## Panther Service Bulletin – Mandatory

**Aircraft:** Panther LS and Panther Sport

**Bulletin Name:** PSB2-M Tail Wheel Bolt

#### Regarding: Mandatory Tail Wheel Bolt

#### **Action Required For Loose Bolt**

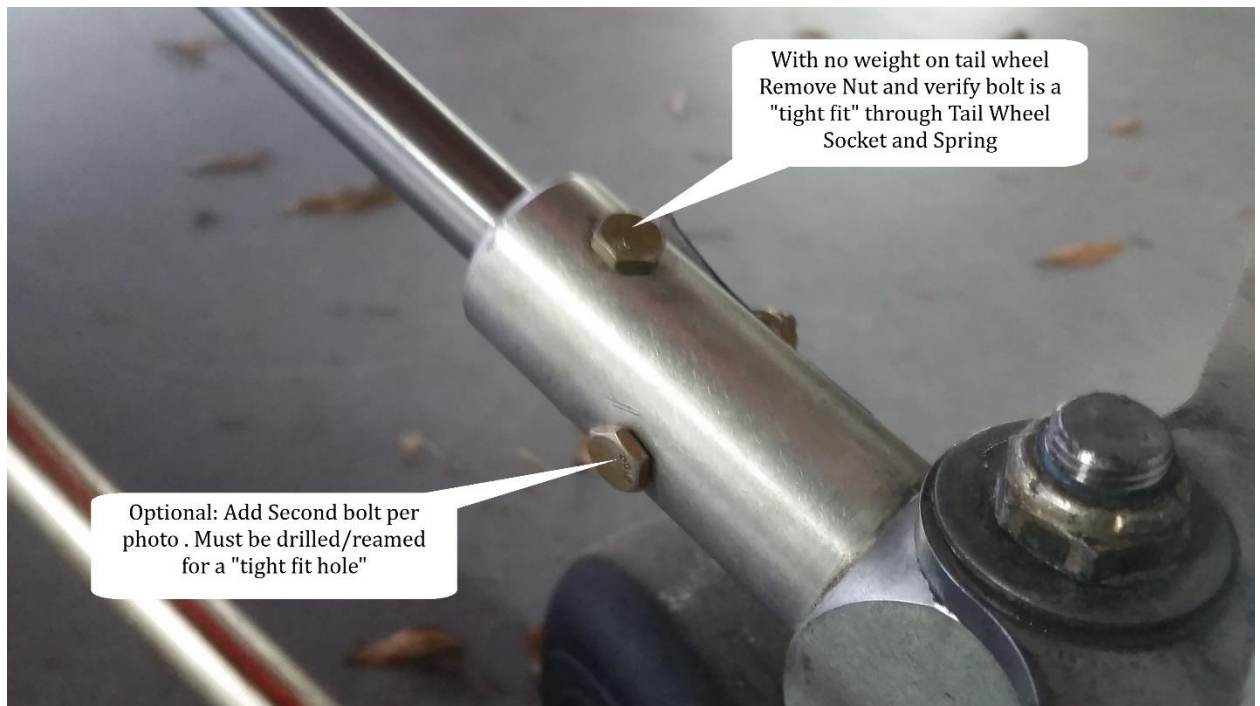
During construction or as retro fit, if any movement is detected or the bolt is not “tight” in the hole.

If any movement is detected after step 1.

1. We recommend acquiring either a close tolerance NAS bolt , or possibly a “first oversize” bolt and the appropriate reamer to install the bolt into a tight fit hole

2. We recommend installing a second bolt per the photo, crosswise  $\frac{3}{4}$ ” behind the first. It MUST be installed into a “tight fit” hole!
